**Project: South Battery Park City Resiliency Project:  
Wagner Park Pavilion Construction Services  
Project (the “Project”) Request for Proposals  
 (“RFP”)**

**Date: April 7, 2022**

**RE: Addendum #8  
# of Pages: 37**

**ATTACHMENT #3**  
**DRAWING C603SE:**  
**WATER AND SEWER PLAN 09**  
*Revised Compared to Exhibit B-1 of RFP*

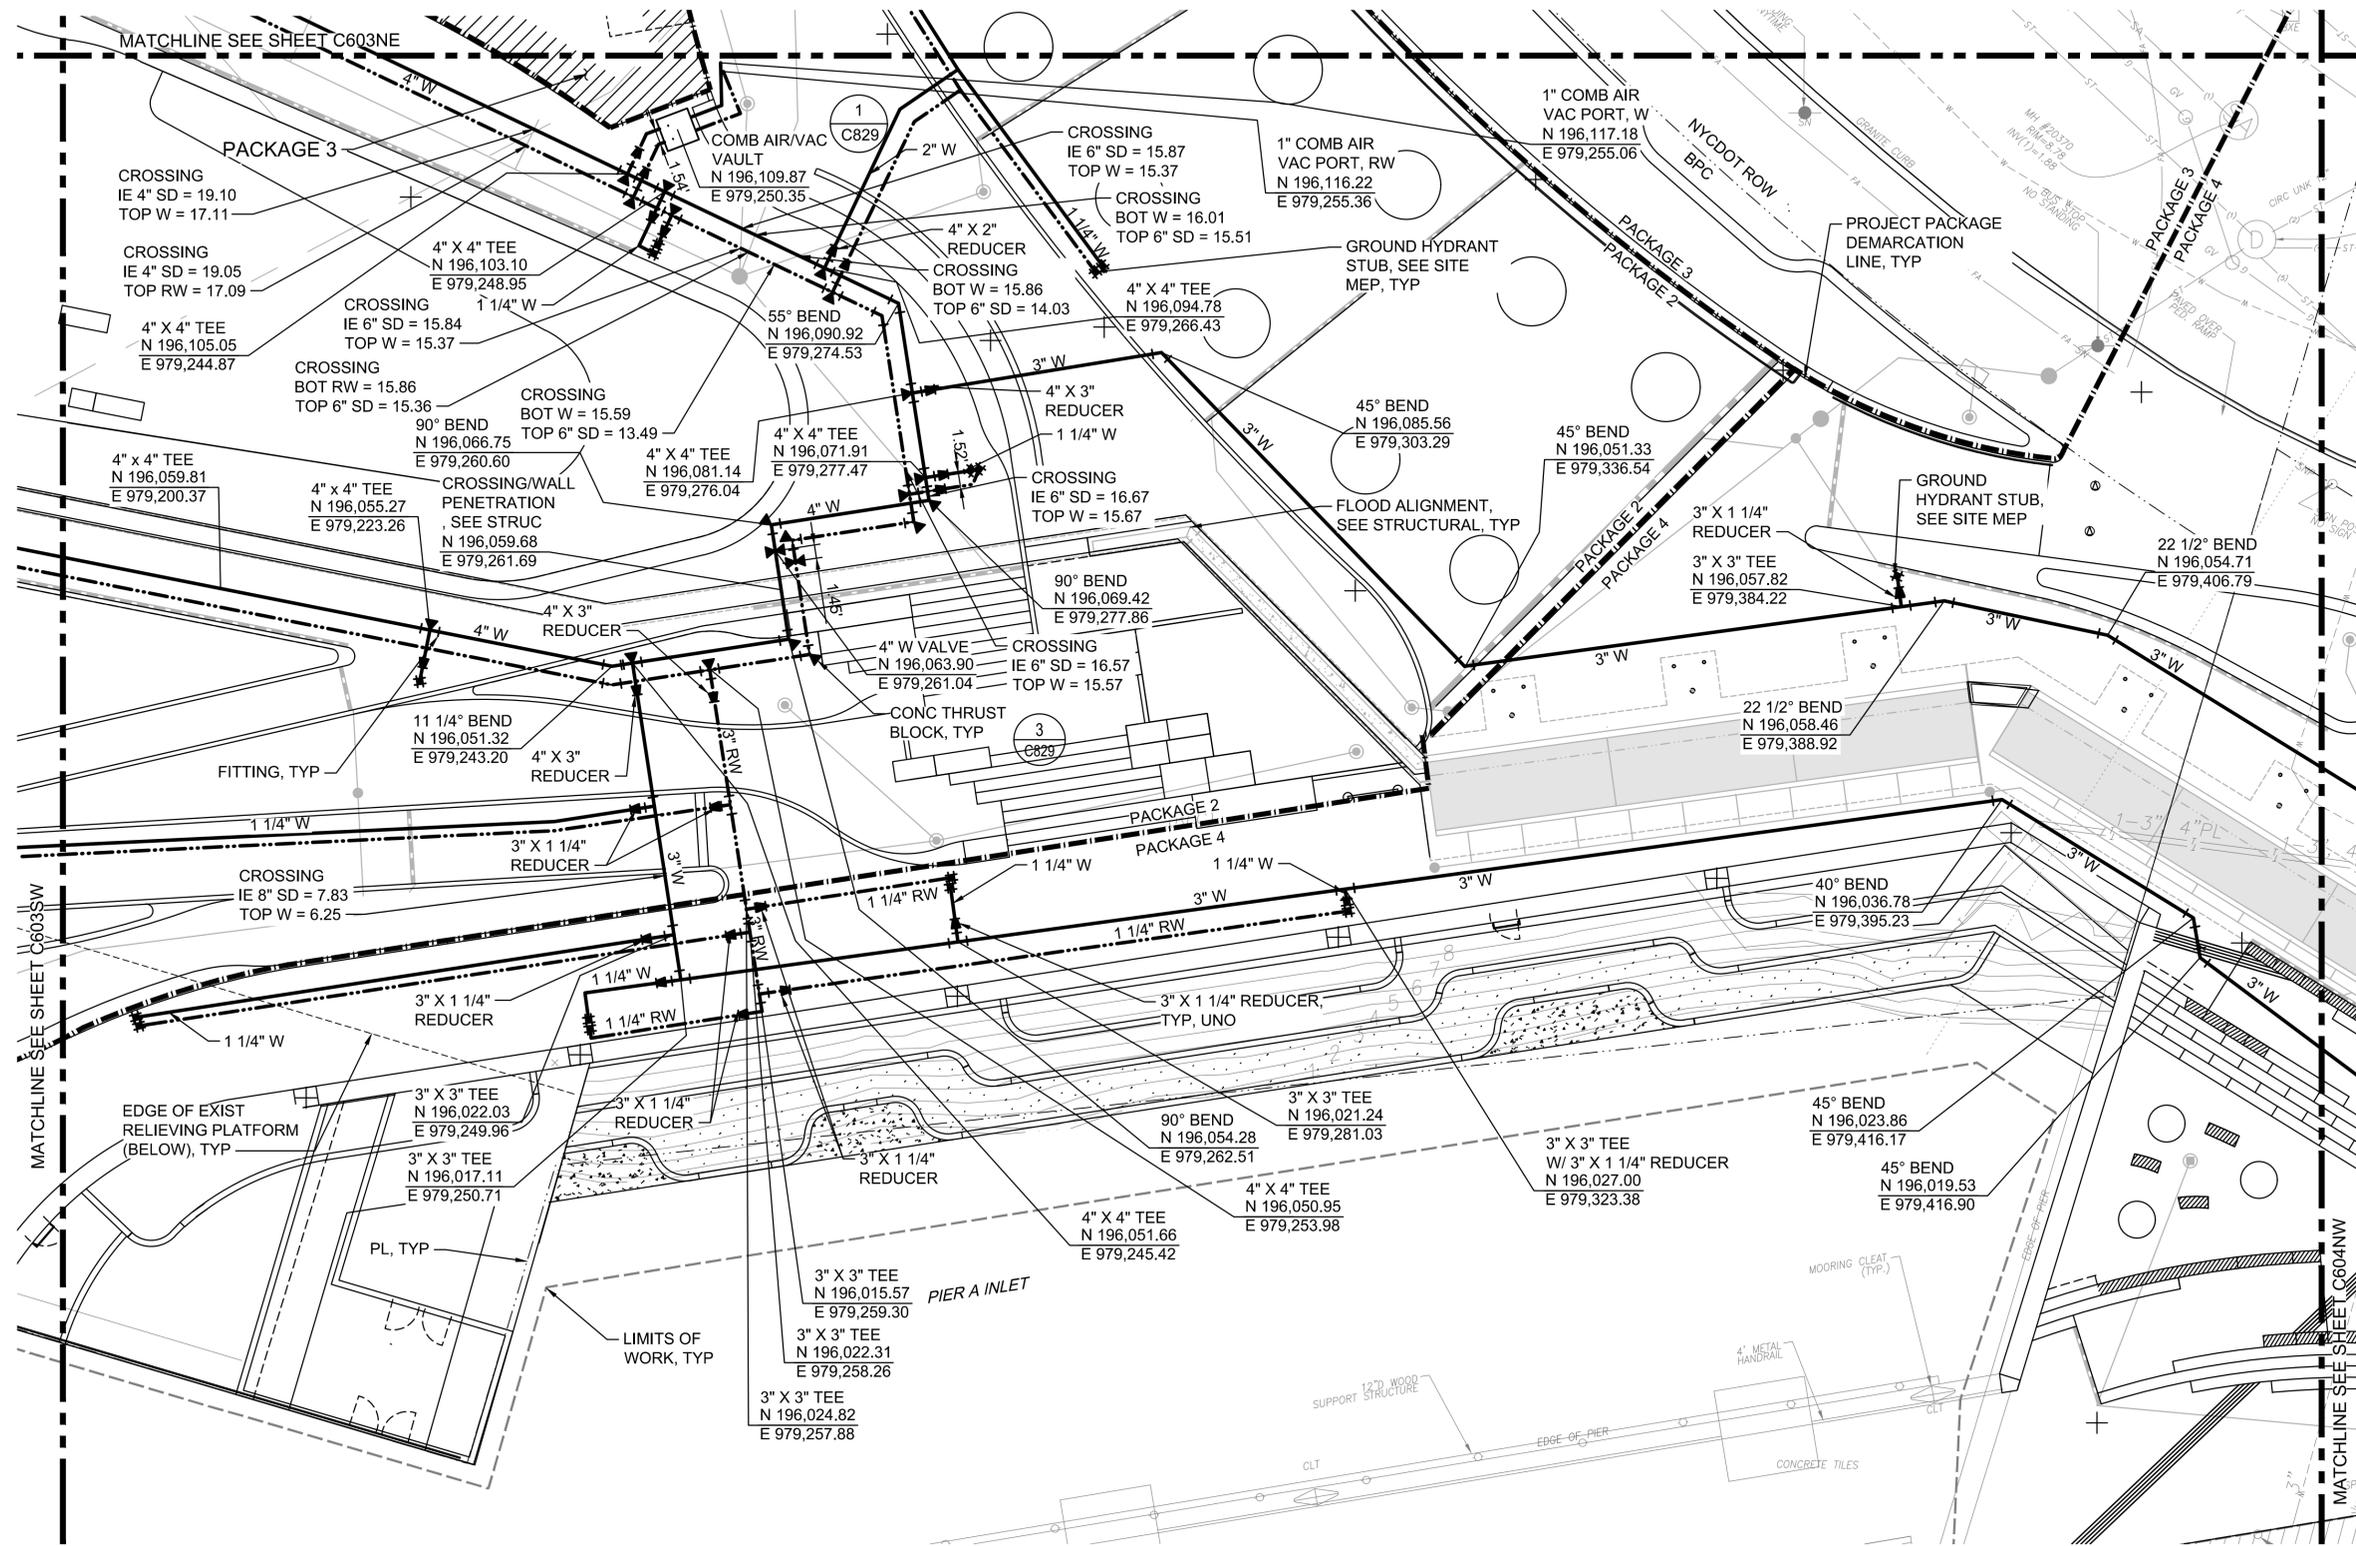
- 39) Drawing C603NE refers to adjoint drawing C603SE. This drawing was not part of the construction documents. Please provide.  
***As stated in Section A – REVISIONS TO RFP (above), Drawing C603SE is provided hereto as Attachment #3.***

2. The following Project sketches and drawings are formally incorporated into the RFP’s Exhibit B-1:
- Sketch #SK-01: Suggested Pile Test Locations dated March 18, 2022 (included as Attachment #2);
  - Drawing C603SE: *Water and Sewer Plan 09* (included as Attachment #3); and,
  - Specification Section 284621.11 – *Addressable Fire-Alarm Systems* is hereby replaced in its entirety to reflect preferred equipment vendors/manufacturers in several locations across Sub-sections 2.2 – 2.10 (included as Attachment #4).
